SERVICE LETTER SL31 66-12020 Rev A

1. **Release Date:** August 29, 2017
2. **Service Letter No.:** SL31 66-12020
3. **Reason for Change:** Dimensions between key areas of floats
4. **Part/Assembly No.:** Drawing 66-12020
5. **Float Model Affected:** 6650
6. **Disposition of Product in Field:** Informational Only
7. **Approval:** All information provided is in accordance with approved data.
8. **Corrective Action:** (Informational Only)
9. **Time Required:** N/A
10. **Payments:** N/A

Figure 1: Shim Location 66-12020

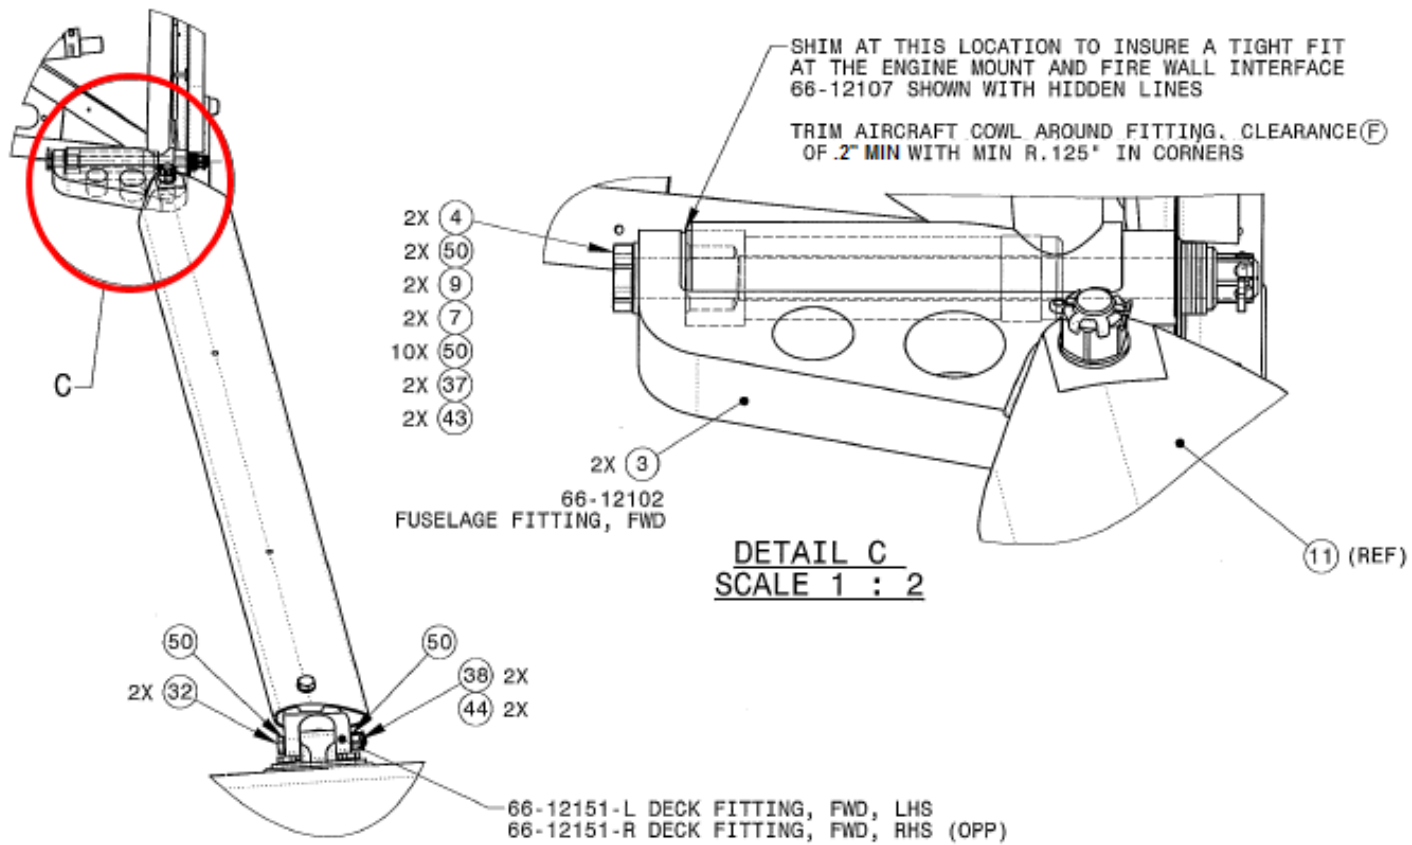
1. There should be a minimum .2" opening around the fitting including the fuselage flange ahead of the firewall. See Figure 1 below.
2. There is some rotational movement on the front fitting. This gap should be opened to keep this from happening.
